State of Oregon Department of Environmental Quality

Written Comments

Willamette Subbasin TMDL

This document is a compilation of written comments received during the public comment period for the Willamette Subbasins TMDL.

Figure 3-22: Johnson Creek field observed and predicted effective shade.

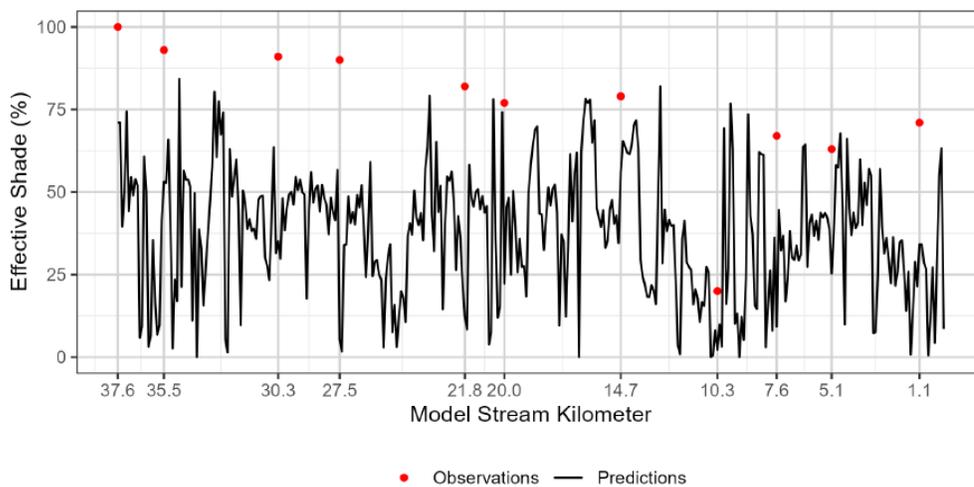
The predominant focus on shade may be insufficient for some subbasins, per the information provided by Appendix A of the Willamette TMDL. DEQ's Effective Shade Model on Johnson Creek is presented in Figure 3-22 of Appendix A in conjunction with actual field measurements of existing shade (pasted below). The model appears to be a poor fit when with the recent field observations presented by DEQ. In a quick comparison, the average modelled shade at the validation points was ~35%, while the real observations at those same points averaged ~79%--more than twice as much real shade as in the model DEQ is using.

A main conclusion from the WQMP documents is that to meet the Water Quality Temperature Standard, DMAs need to increase shade, and that if we increased shade to its potential, we would generally stay below the Standard (see Fig 4-1 in the same Appendix document). However, if Johnson Creek already has more than twice the shade that the model suggests and yet that subwatershed is still routinely exceeding the temperature standard, will this predominant focus on stream shade result in temperature improvements as assumed by the DEQ modeling? These data sources suggest Gresham would be expected to increase shade where it is already at or near full potential. And, while the conflict between the Effective Shade model and actual conditions sets the jurisdiction up to easily demonstrate improved stream shade conditions when comparing current conditions against the 2002 baseline (as established by the Effective Shade Model), Gresham is motivated to invest efforts where public resource investment will contribute to real temperature improvements when combined with the investment of other Johnson Creek stakeholders.

Figure 1. Distribution of effective shade values in pre-harvest streams in six major watershed studies in Western Oregon. Studies with an asterisk represent canopy closure values as opposed to hemispherical shade.

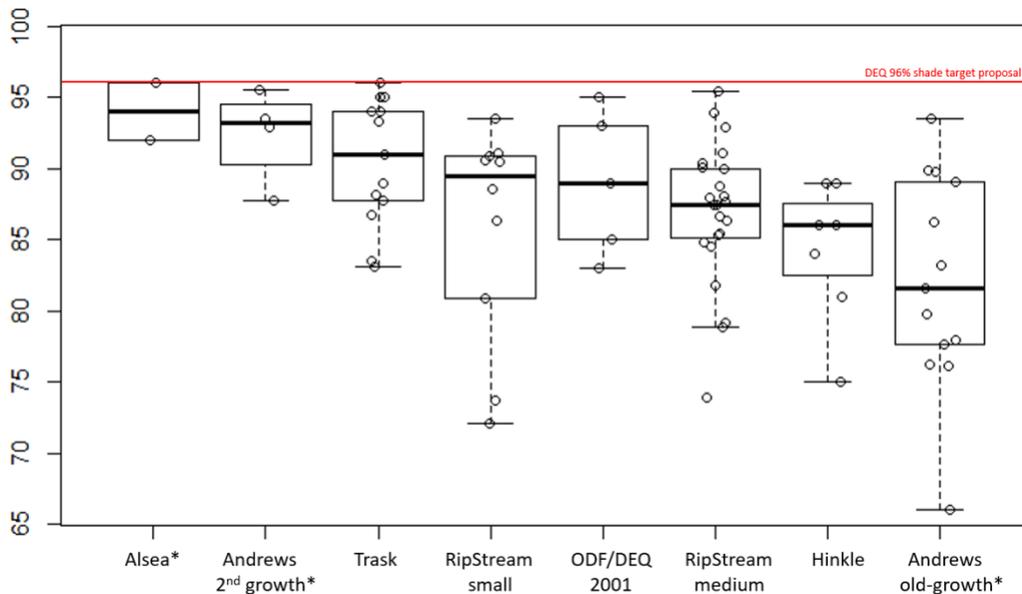
A review of six published shade studies has provided us with shade data from dense, second-growth forests in Western Oregon, which provide ideal shading conditions (Allen and Dent, 2001; Bladon et al., 2016; Groom et al., 2011; Kibler, 2007; Reiter et al., 2020; Warren et al., 2013). One study took place in the H.J. Andrews Experimental Forest and was split into two datasets to represent old-growth and second-growth forests separately (Warren et al., 2013). A second study, typically referred to as the “RipStream” study, was split into two datasets to represent small and medium sized streams separately (Groom et al., 2011). Out of the 77 pre-harvest study sites examined within these eight datasets, only 2 individual sites reach a value of 96% effective shade (Figure 1). No watershed study reached an average of 96% shade, and median shade values ranged from below 85% to between 90% and 95%. There is also significant variability within datasets, even among pre-harvest streams. We expect these pre-harvest streams to be representative of the restored shade conditions that DEQ has attempted to model. It is therefore unrealistic to expect restored shade conditions to exceed the shade conditions established by these studies, and we believe the "ODF - Private" effective shade target of 96% for the Southern Willamette Basin to be practically unattainable.

We understand from our conversation with DEQ on 5 February 2024 that the high effective shade values in the restored vegetation model, and the difference between model output and shade data from dense, second-growth forests, cannot be explained. This suggests that the model is not well calibrated at high shade values. It is therefore inappropriate for this model output to be used as a regulatory target.

Figure 2. Measured shade values as reported in DEQ (2024), Table 2-38.

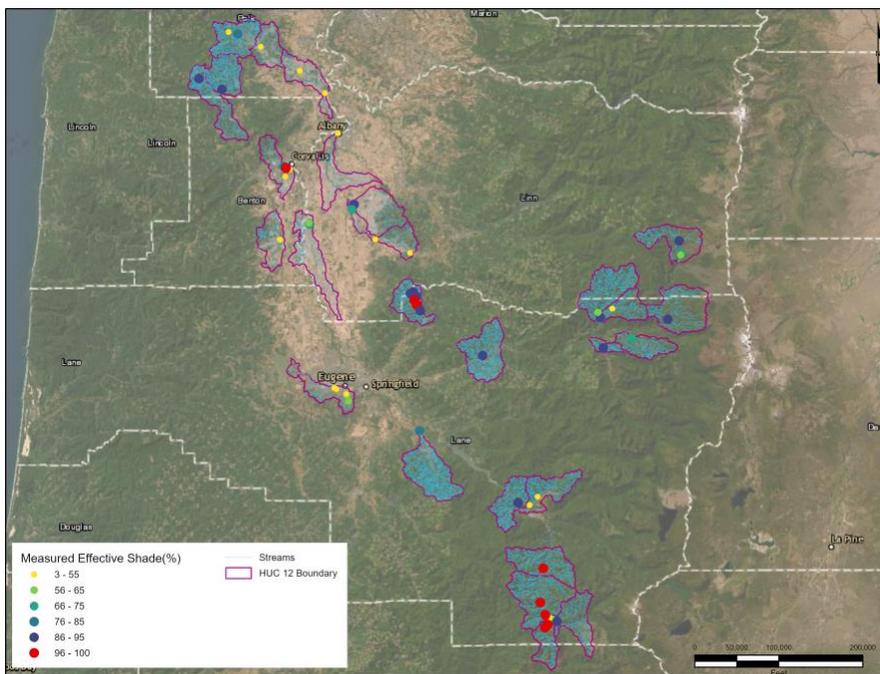
Figure 2 shows the measured values used to calibrate the model, as reported in Table 2-38 of the Heat Source Model Report (DEQ, 2024), along with the applicable HUC12 boundaries. The figure demonstrates that the 9 shade measurements of 96% or greater are located in three geographical areas:

- Five of the 9 measurements, including all four of the measurements greater than 96%, are located in close geographic proximity in Southern Lane County, in the Middle Fork Willamette area, specifically the Packard Creek-Middle Fork Willamette River, Buck Creek-Middle Fork Willamette River, and Coal Creek HUC12 subbasins.
- Three of the 9 measurements are located in the Shotcash Creek-Mohawk River HUC12 subbasin.
- One measurement is located in the Lower Mary’s River HUC12 subbasin.

The clustering of these shade measurements of 96% or greater, while numerous other measurements in areas of dense shade show substantially lower values, suggests potential inconsistency in the measurements. For example, use of different instruments or personnel, or inconsistent calibration, in some areas may result in elevated measurements inconsistent with other measurements. To the extent that these measurements are biased high, and given that even in dense, mature, second-growth forests, 96% shade is very rarely reached, this would have biased the calibration process—an inappropriately high Canopy Cover value would have been selected in the model to best match the biased measurements. This would have led to modeled values biased high in all modeled areas.

Figure 3. DEQ scatterplot assessing calibration of the Southern Willamette shade model. Reproduced from DEQ, 2024.

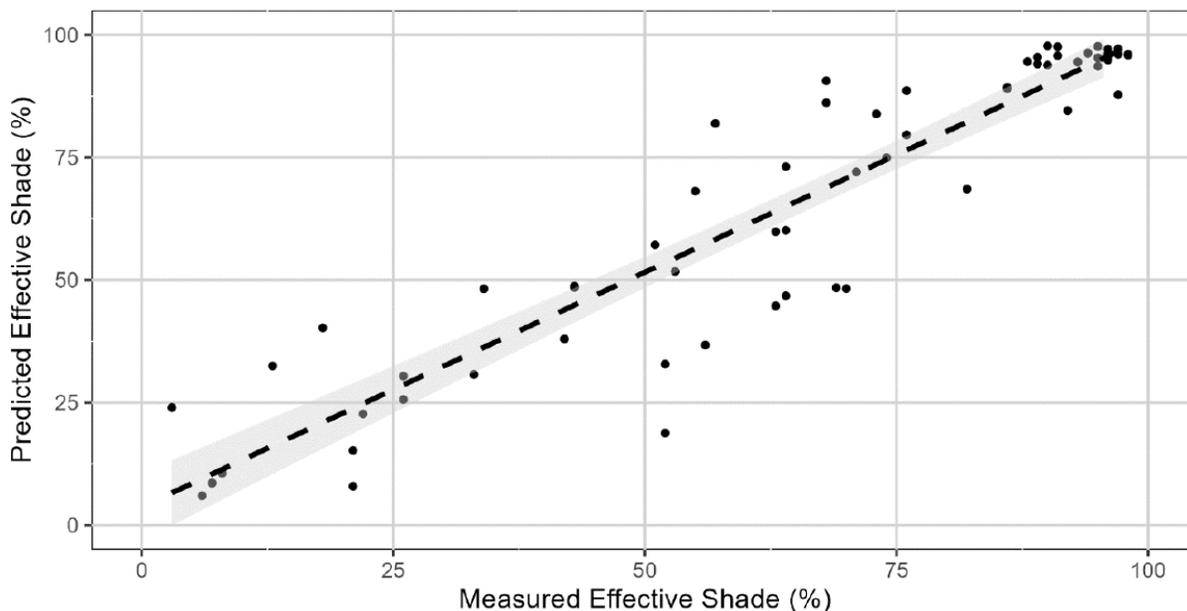
We also note, based on DEQ’s calibration scatterplot (Figure 3-248, reproduced below as Figure 3), that the model overpredicts measured values—even the measured values that appear unrealistically high—for high effective shade. The figure appears to show that for 27 of the 30 measurement points where measured shade exceeded 75% (based on Table 2-38), the modeled shade was equal or greater than the measured value, while only 3 of the measured points fall notably below the line. This again indicates that the model was calibrated to predict very high shade for forested areas, and the results are biased high as a result.

Figure 4. Middle Mosby Creek Subbasin nodes modeled as disturbed versus undisturbed.

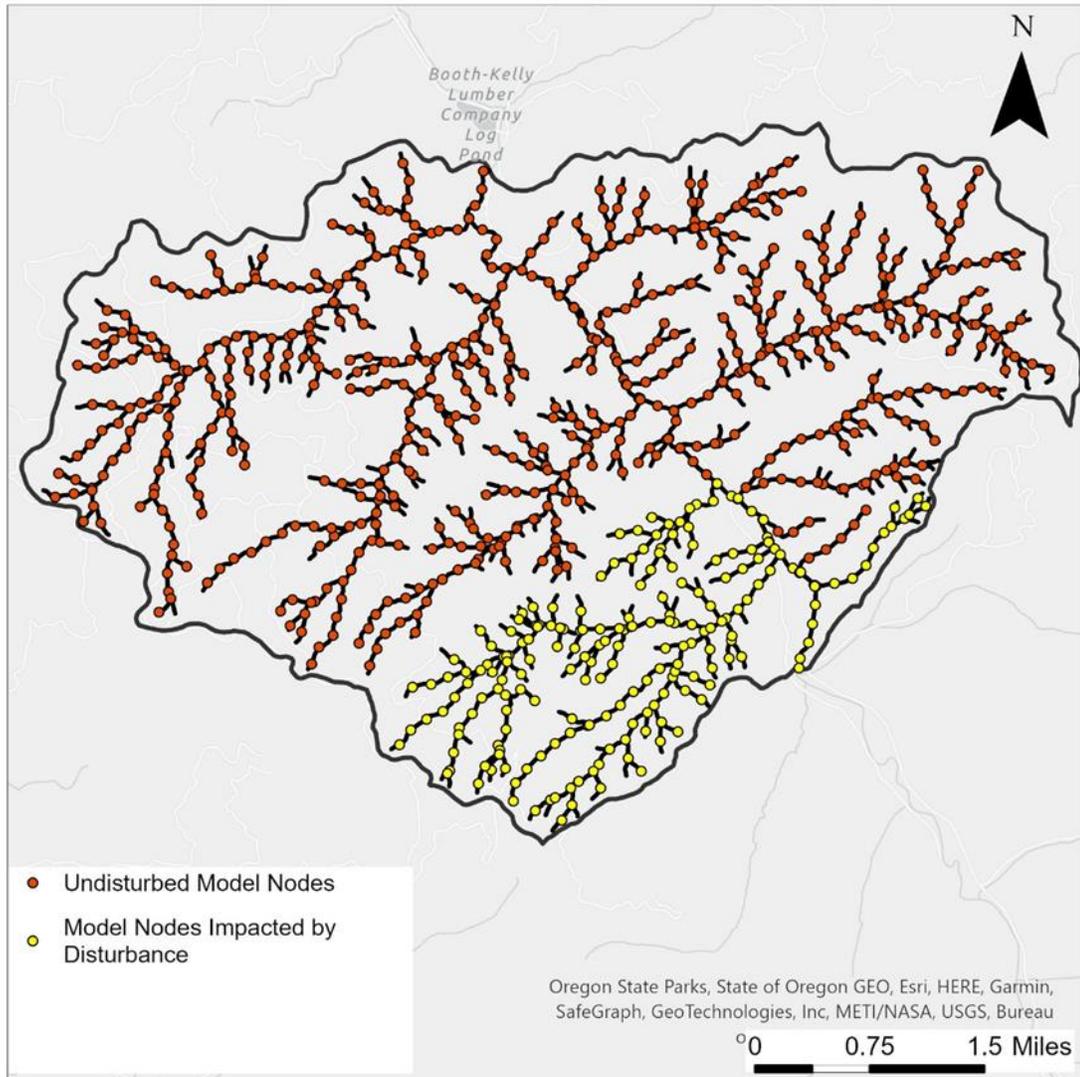
To evaluate the effects of our suggested approach for modeling disturbance, we evaluated a contiguous 25% disturbance, following the approach described above. A contiguous 25% disturbance was used, rather than our recommended value of 35%, for comparison to the results in the draft TMDL. Specifically, we evaluated this approach for an example HUC12 subbasin, Middle Mosby Creek. This subbasin was selected as an example of a subbasin covered by forestland under the restored conditions scenario.

Figure 4 indicates the modeled scenario—the nodes highlighted yellow were selected as "disturbed" and all vegetation providing shade for these nodes used the "Disturbed" forestland condition (56-foot tree height, 25% density, and 2.0-meter overhang as outlined in Appendix C of the Technical Support Document). The remaining vegetation was assigned the "No Disturbance" forestland condition (160-foot tree height, 75% density, 4.9-meter overhang).

Figure 5. Comparison of DEQ Restored Conditions scenario to Contiguous 25% Disturbance "By Node" Scenario for Middle Mosby Creek.

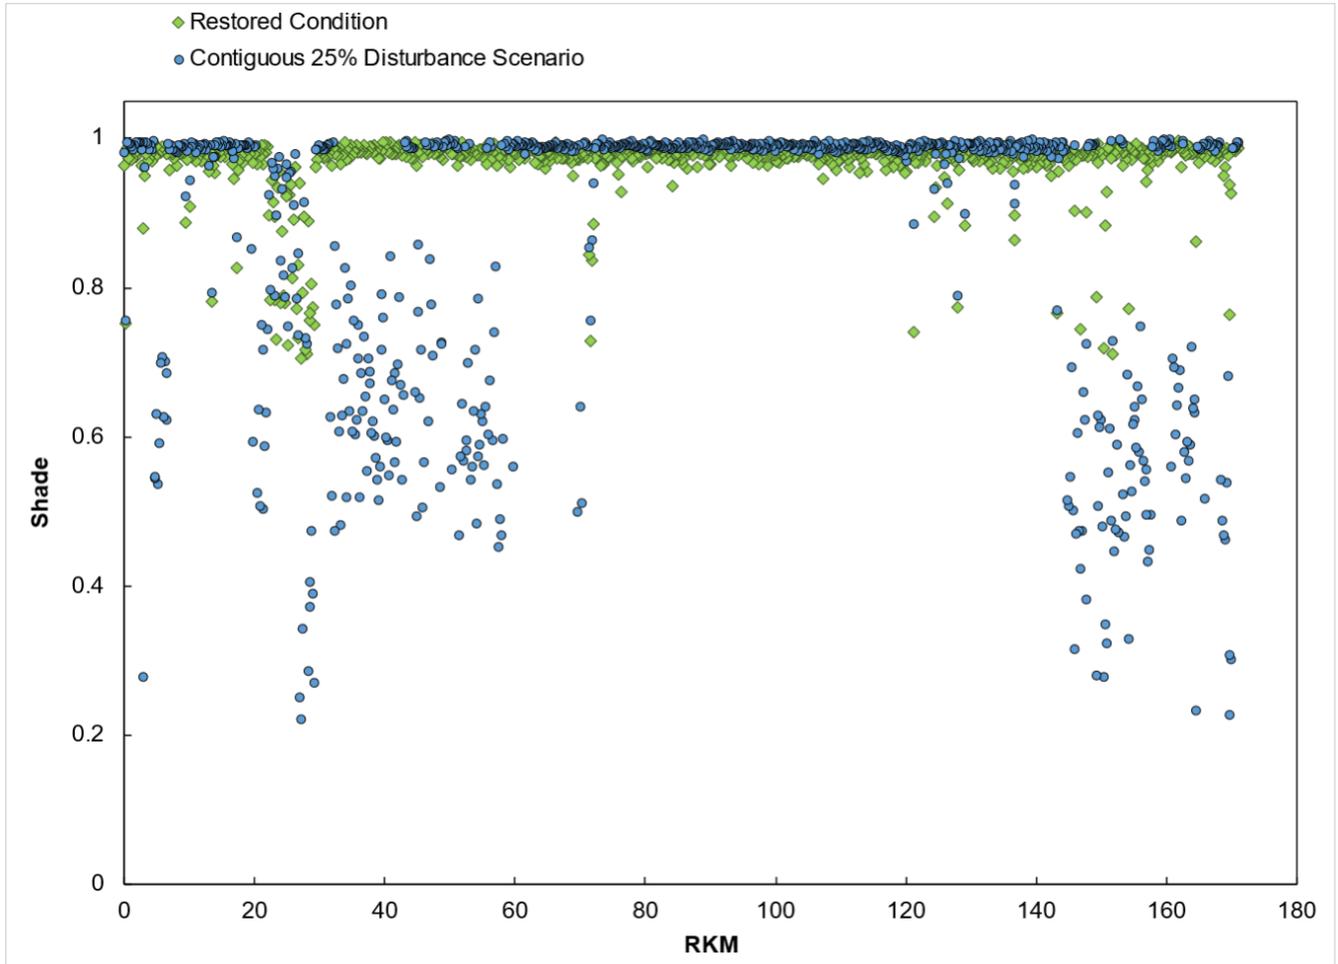
We ran the shade model provided by DEQ for the condition described above and compared the results to the output for Middle Mosby Creek for DEQ’s restored conditions scenario. Figure 5 presents a comparison of the modeled shade. Specifically, each green dot in Figure 5 represents a modeled node from DEQ’s restored conditions scenario. There is a corresponding blue dot for each modeled node using the Contiguous 25% disturbance scenario. The figure indicates that, for many nodes, there is slightly more shade under the Contiguous 25% disturbance scenario—this is because the vegetation surrounding these nodes is fully undisturbed under the Contiguous 25% disturbance scenario, whereas there is random disturbance included in the DEQ restored conditions scenario. However, Figure 5 also shows that for nodes modeled as “disturbed,” much less shade is provided under the Contiguous 25% disturbance scenario compared with the restored conditions scenario. Importantly, these nodes do not receive 0% shade—the disturbed forestland condition described in Appendix C of the still includes 56-foot tall trees with 25% density. Nevertheless, when averaged over the modeled nodes for Middle Mosby Creek, the

restored condition average from the draft TMDL method for this subbasin is **97%**, while the average using the Contiguous 25% disturbance approach is **88%**. This analysis indicates that using a more realistic approach to modeling disturbance would result in a lower, and more justifiable, shade target.

We note again here that this example used a Contiguous 25% Disturbance, for purposes of comparison to DEQ's restored conditions scenario. However, based on our review of the literature, we request that DEQ use 35% disturbance.

Figure 1. Distribution of effective shade values in pre-harvest streams in six major watershed studies in Western Oregon. Studies with an asterisk represent canopy closure values as opposed to hemispherical shade.

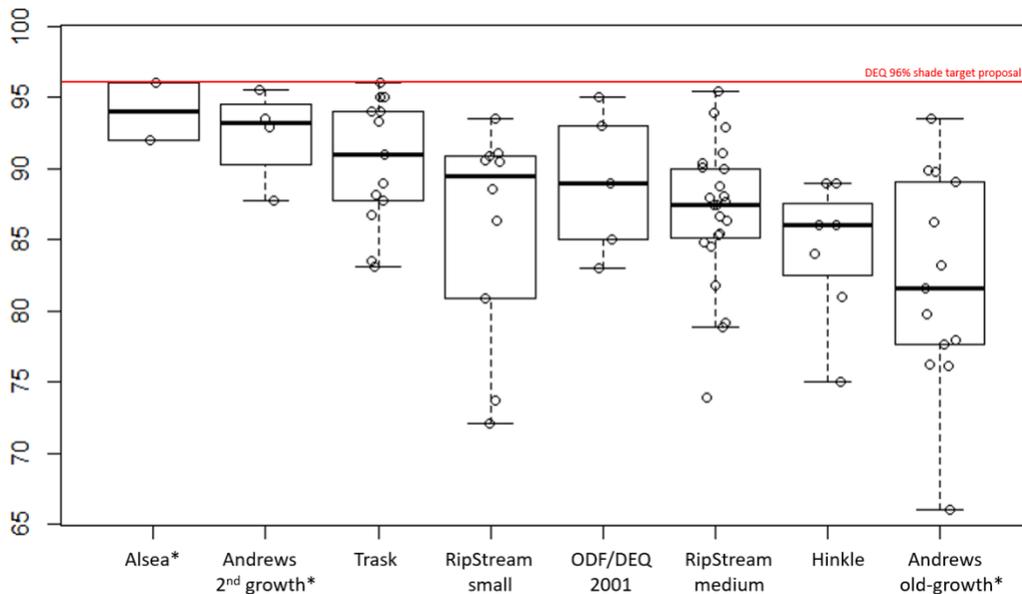
A review of six published shade studies has provided us with shade data from dense, second-growth forests in Western Oregon, which provide ideal shading conditions (Allen and Dent, 2001; Bladon et al., 2016; Groom et al., 2011; Kibler, 2007; Reiter et al., 2020; Warren et al., 2013). One study took place in the H.J. Andrews Experimental Forest and was split into two datasets to represent old-growth and second-growth forests separately (Warren et al., 2013). A second study, typically referred to as the “RipStream” study, was split into two datasets to represent small and medium sized streams separately (Groom et al., 2011). Out of the 77 pre-harvest study sites examined within these eight datasets, only 2 individual sites reach a value of 96% effective shade (Figure 1). No watershed study reached an average of 96% shade, and median shade values ranged from below 85% to between 90% and 95%. There is also significant variability within datasets, even among pre-harvest streams. We expect these pre-harvest streams to be representative of the restored shade conditions that DEQ has attempted to model. It is therefore unrealistic to expect restored shade conditions to exceed the shade conditions established by these studies, and we believe the "ODF - Private" effective shade target of 96% for the Southern Willamette Basin to be practically unattainable.

We understand from our conversation with DEQ on 5 February 2024 that the high effective shade values in the restored vegetation model, and the difference between model output and shade data from dense, second-growth forests, cannot be explained. This suggests that the model is not well calibrated at high shade values. It is therefore inappropriate for this model output to be used as a regulatory target.

Figure 2. Middle Mosby Creek Subbasin nodes modeled as disturbed versus undisturbed.

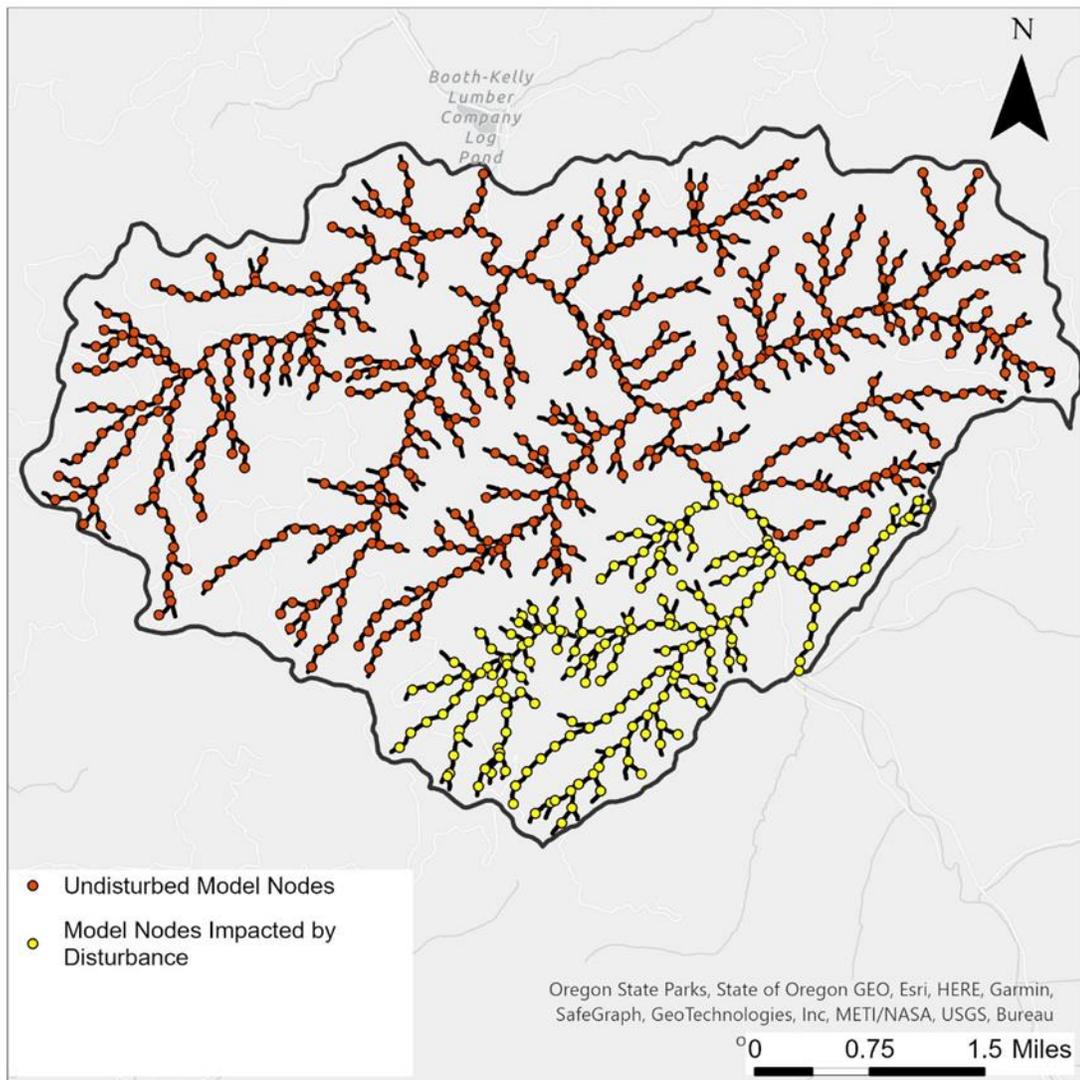
in the draft TMDL. Specifically, we evaluated this approach for an example HUC12 subbasin, Middle Mosby Creek. This subbasin was selected as an example of a subbasin covered by forestland under the restored conditions scenario.

Figure 2 indicates the modeled scenario—the nodes highlighted yellow were selected as “disturbed” and all vegetation providing shade for these nodes used the “Disturbed” forestland condition (56-foot tree height, 25% density, and 2.0-meter overhang as outlined in Appendix C of the Technical Support Document). The remaining vegetation was assigned the “No Disturbance” forestland condition (160-foot tree height, 75% density, 4.9-meter overhang).
